**IMMULITE®
IMMULITE® 1000**

IMMULITE and IMMULITE 1000 Total Testosterone Positive Bias

Reason for Correction

Figure 1. Current IMMULITE/IMMULITE 1000 Total Testosterone vs. IMMULITE 2000/IMMULITE 2000 XPI Total Testosterone Graph

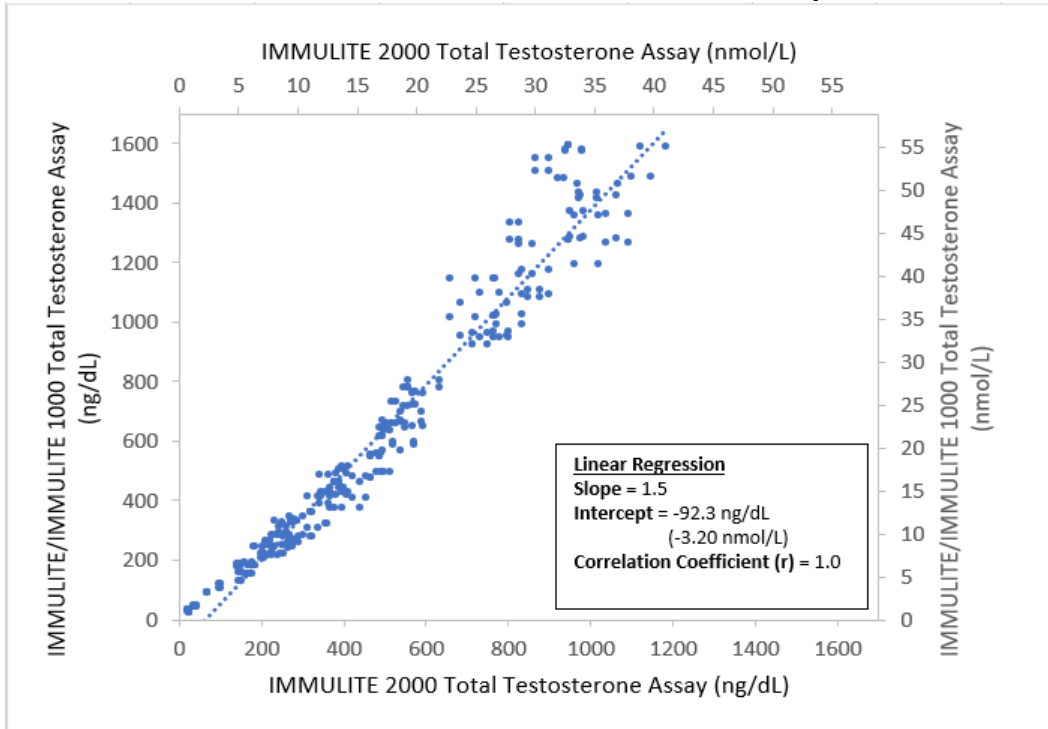
Siemens Healthcare Diagnostics Inc. has confirmed an average positive bias of 40% for testosterone concentrations of approximately 660 ng/dL (22.9 nmol/L) and above with the IMMULITE/IMMULITE 1000 Total Testosterone Assay when compared to the IMMULITE 2000/IMMULITE 2000 XPi Total Testosterone Assay. The observed bias is not proportional across the assay range; biases below a dose of approximately 660 ng/dL are equivalent to historical performance. See Additional Information section below for details.

IMMULITE/IMMULITE 1000 Total Testosterone performance compared to IMMULITE 2000/IMMULITE 2000 XPi was evaluated with 100 serum samples across the assay calibration range (20 – 1600 ng/dL; 0.7 – 55 nmol/L) and two kit lots per platform. Figure 1 shows the biases observed for results within the assay calibration range when comparing representative lots (516 and below) of IMMULITE/IMMULITE 1000 Total Testosterone Assay to the IMMULITE 2000/IMMULITE 2000 XPi Total Testosterone Assay.

- Please review this letter with your Medical Director.
- You may continue use of the IMMULITE/IMMULITE 1000 Total Testosterone Assay kit lots listed in Table 1 to report values below 660 ng/dL (22.9 nmol/L) until you receive replacement product in your laboratory. Refer to Figures 1 and 2 for IMMULITE/IMMULITE 1000 Total Testosterone bias information.

Figure 3. IMMULITE/IMMULITE 1000 Total Testosterone Kit Lot 550 vs. IMMULITE 2000/IMMULITE 2000 XPi Total Testosterone Kit Lots 635, 638, and 639 Graph

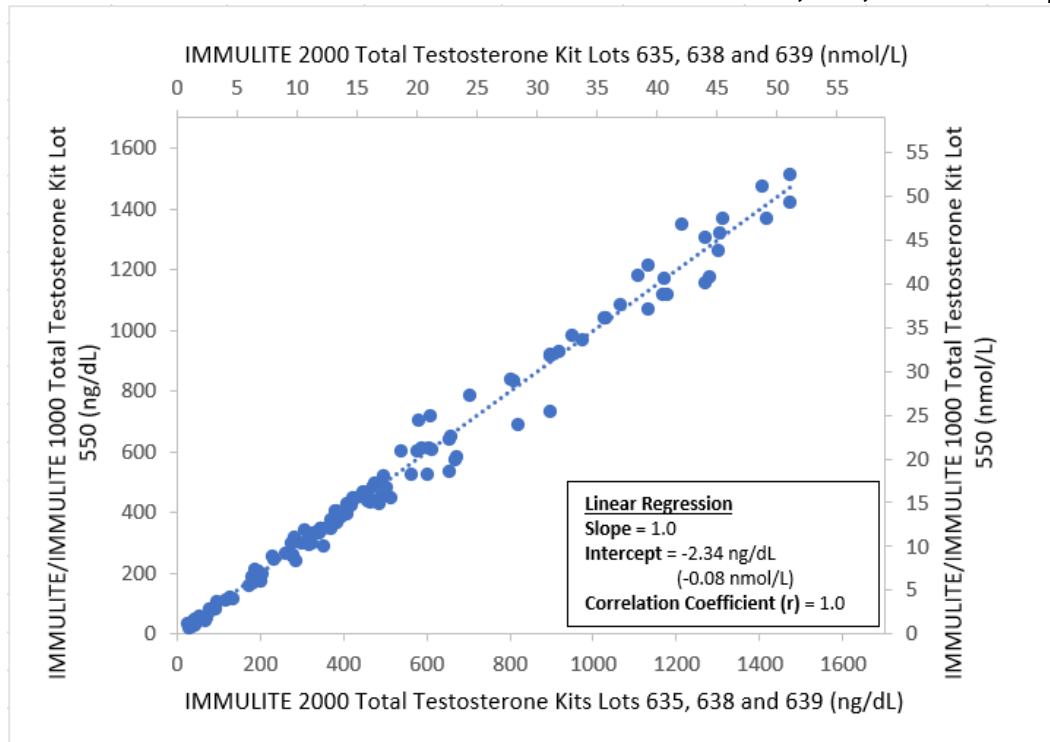
Evaluation of the IMMULITE/IMMULITE 1000 Total Testosterone assay compared to IMMULITE 2000/IMMULITE 2000 XPi utilized 123 patient samples covering the assay calibration range (20 – 1600 ng/dL; 0.7 – 55 nmol/L) with IMMULITE/IMMULITE 1000 Total Testosterone Kit Lot 550 versus IMMULITE 2000/IMMULITE 2000 XPi Total Testosterone Kit Lots 635, 638, and 639.

Figures 3 and 4 demonstrate Total Testosterone result alignment between the IMMULITE/IMMULITE 1000 and IMMULITE 2000/IMMULITE 2000 XPi Systems has been restored.

Alignment to the IMMULITE 2000/IMMULITE 2000 XPi Total Testosterone Assay has been restored with IMMULITE/IMMULITE 1000 Total Testosterone Assay Kit Lots 550 and above (available in October 2022).

Figure 5. IMMULITE/IMMULITE 1000 Total Testosterone Kit Lot 550 vs. Kit Lot 515 Graph

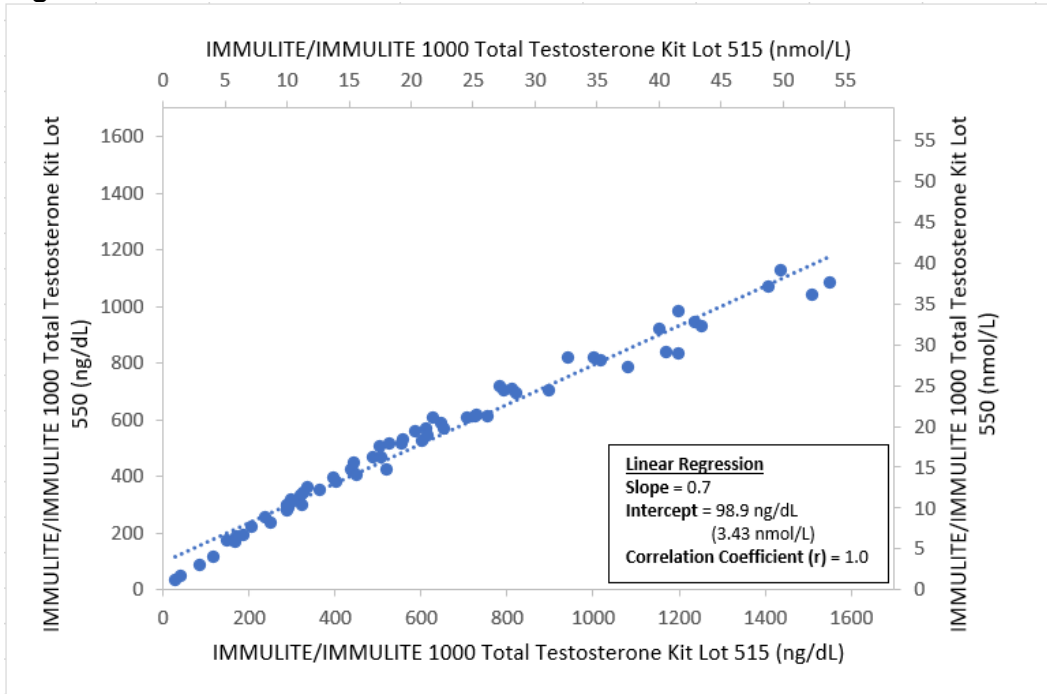
After restoring alignment to the IMMULITE 2000/IMMULITE 2000 XPi, Siemens completed internal testing to evaluate the performance of IMMULITE/IMMULITE 1000 Total Testosterone Kit Lot 550 compared to IMMULITE/IMMULITE 1000 Total Testosterone Kit Lot 515. Method comparison studies included 65 samples across the assay calibration range (20 – 1600 ng/dL; 0.7 – 55 nmol/L) to evaluate the performance. The observed method comparison results are representative of IMMULITE/IMMULITE 1000 Total Testosterone Kit Lot 550 compared to IMMULITE/IMMULITE 1000 Total Testosterone Kit Lot 515.

Figures 5 and 6 show the approximate overall average negative 7% shift that is expected when transitioning to Kit Lot 550 and above.

Customers will observe a negative shift when transitioning from the kit lots listed in Table 1 to the restored Kit Lots 550 and above. See Additional Information section below for details on the expected shift.
